INDESIT company

ARMXXL129EU/HA

F054586

n4008f00: Thermic link wire removed on three-phase motor

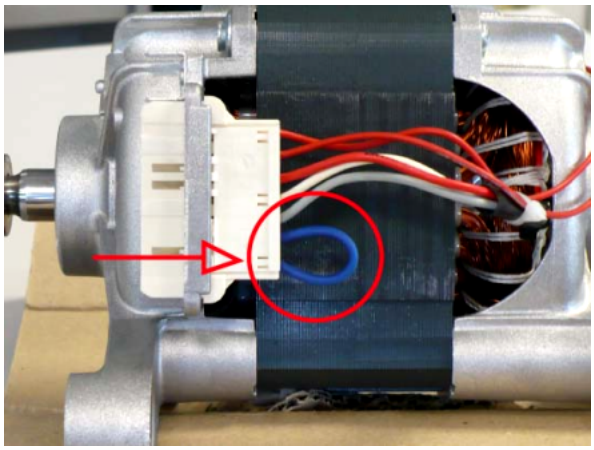
Attention!
When you assist the premodification models using the new motor code you MUST use the thermic link wire code C00265838.

The spare part warehouses will manage the premodification motor until the end of the stock, after they will be replaced with new ones and thermic link wire.

TRIPHASE P40 46 L – INOX TUB
C00265827 new motor without thermic link wire - C00116103 premodification motor with thermic link wire

TRIPHASE P40 46 L – PLASTIC TUB
C00265826 new motor without thermic link wire - C00142390 premodification motor with thermic link wire

TRIPHASE P50 52 L
C00265829 new motor without thermic link wire - C00142205 premodification motor with thermic link wire

TRIPHASE P32 46 L TOP LOADING
C00265832 new motor without thermic link wire - C00262375 premodification motor with thermic link wire

TRIPHASE P40 46 L TOP LOADING
C00265834 nuovo new motor without thermic link wire - C00112739 premodification motor with thermic link wire

In the attached image you can see the fixing of thermic link wire in the motor therminal box.
